SB-10055537-3173

REFERENCE:	Nova Bus Manuals
SECTION:	08: Braking system
RS Nº:	MQR 7621-534
EFFECTIVE IN PROD.:	–

SUBJECT:	Rear axle brake system
JUSTIFICATION:	Irregular vehicle movement at very low speed

Figure 3 - Hoses to be Disconnected

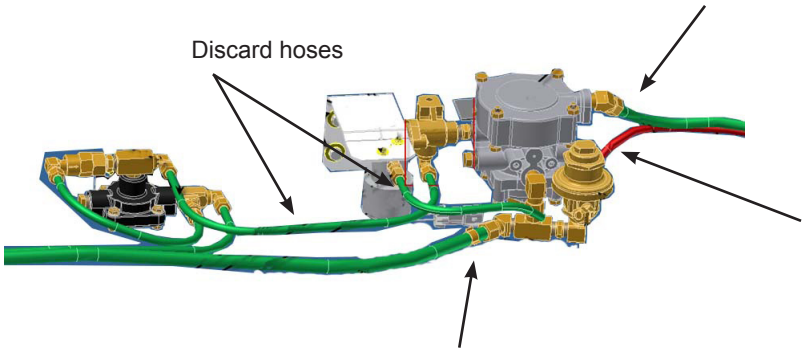
1.6. Disconnect the air hoses connected to the drift valve and double relay valve.

1.7. Discard the hoses shown in Figure 3.

Figure 4 - Valve Assembly Removal

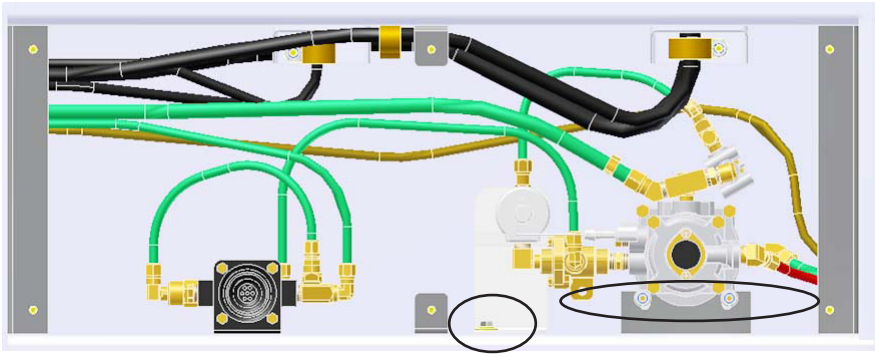
1.8. Remove the bolts holding the double relay valve. Retain the hardware.

1.9. Remove the bolts holding the drift valve. Take out the assembly from the enclosure. Reinstall the hardware.

Figure 5 - Remove 1200 or 5000 Series Valve

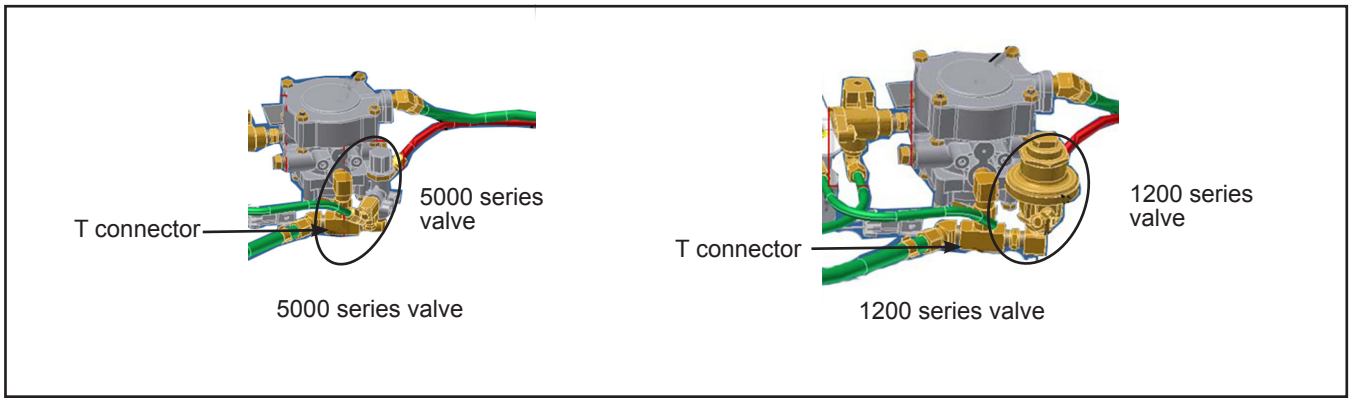
1.10. Remove the valve from the T connector.

Figure 6 - Remove the Drift Valve

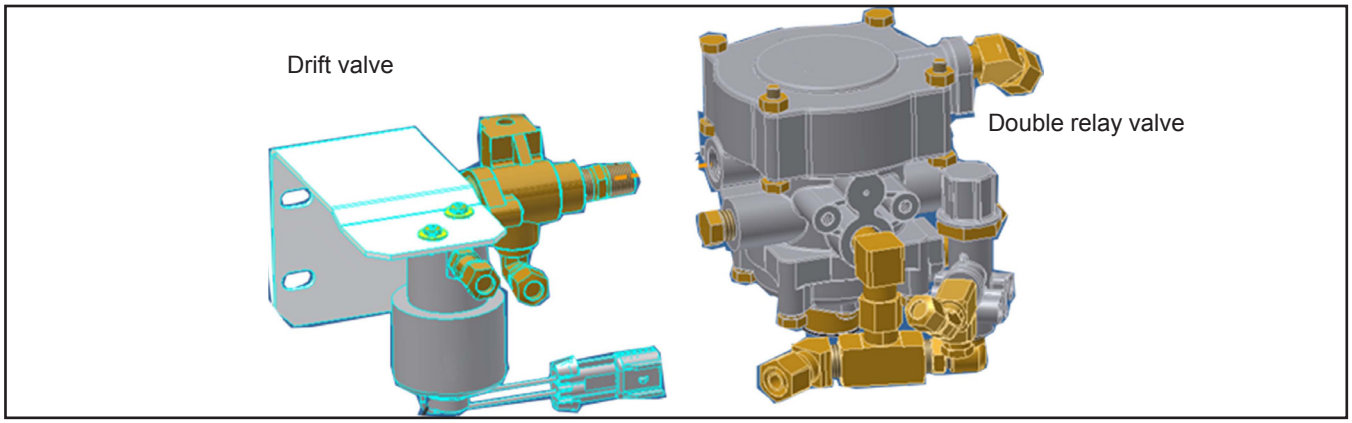
1.11. Disassemble the drift valve from the double relay valve.

1.12. Discard the drift valve.

Figure 7 - Fittings Installation

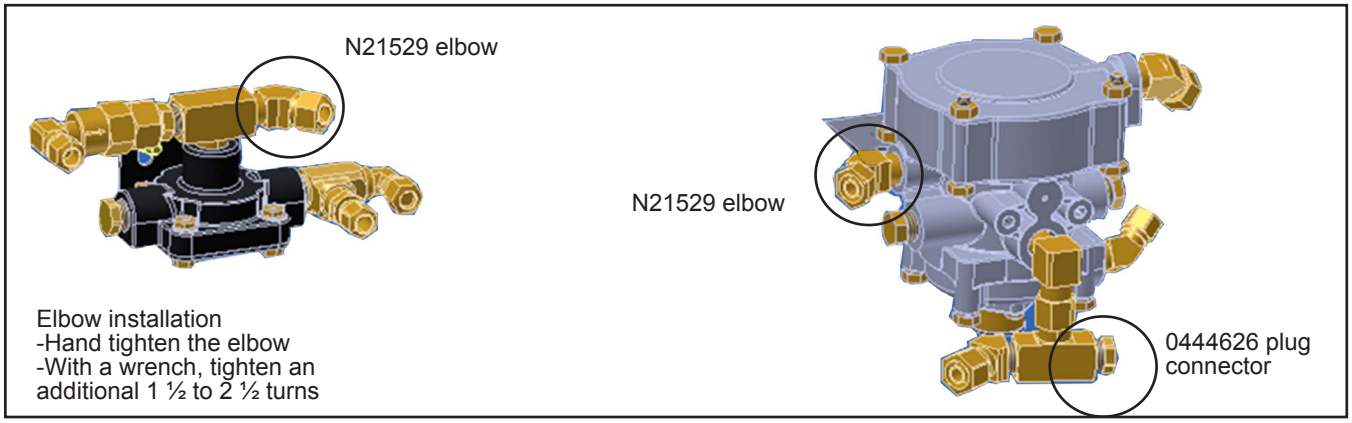
1.13. Install and tighten a 0444626 plug connector to the T connector.
1.14. Install a new N21529 connector to the double relay valve.
1.15. Install a new N21529 connector to the existing assembly.

Figure 8 - Hoses Installation

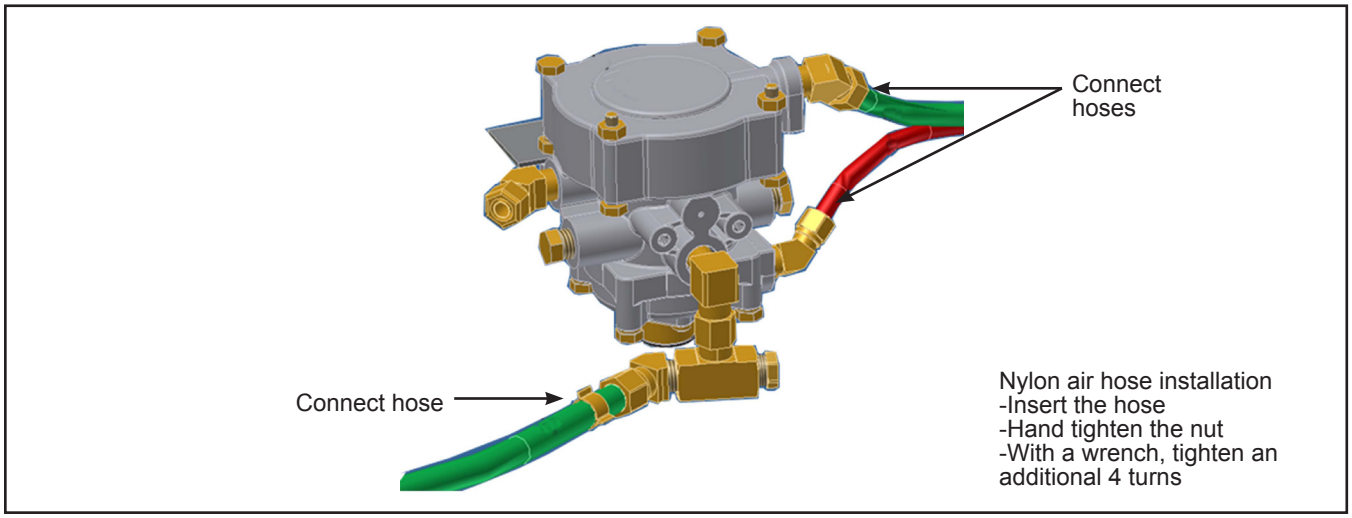
1.16. Install the dual relay valve with the retained hardware in the enclosure.
1.17. Connect the three existing air hoses.

Figure 9 - New 8861149 Hose Installation

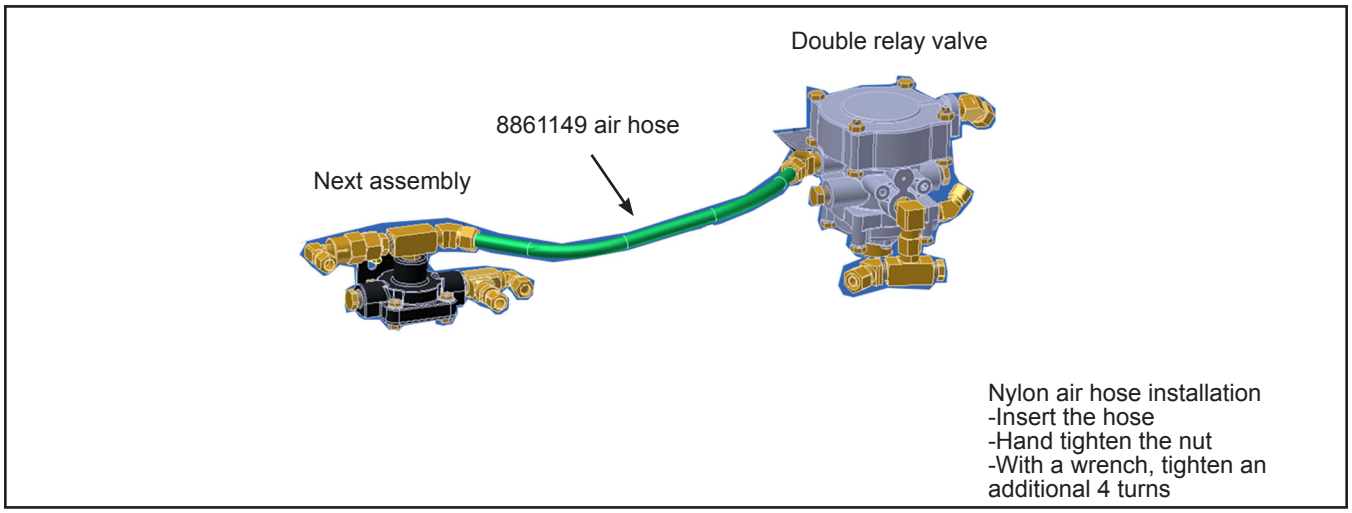
1.18. Cut to size the 8861149 air hose that connects the next assembly to the double relay valve.
1.19. Connect the air hose.
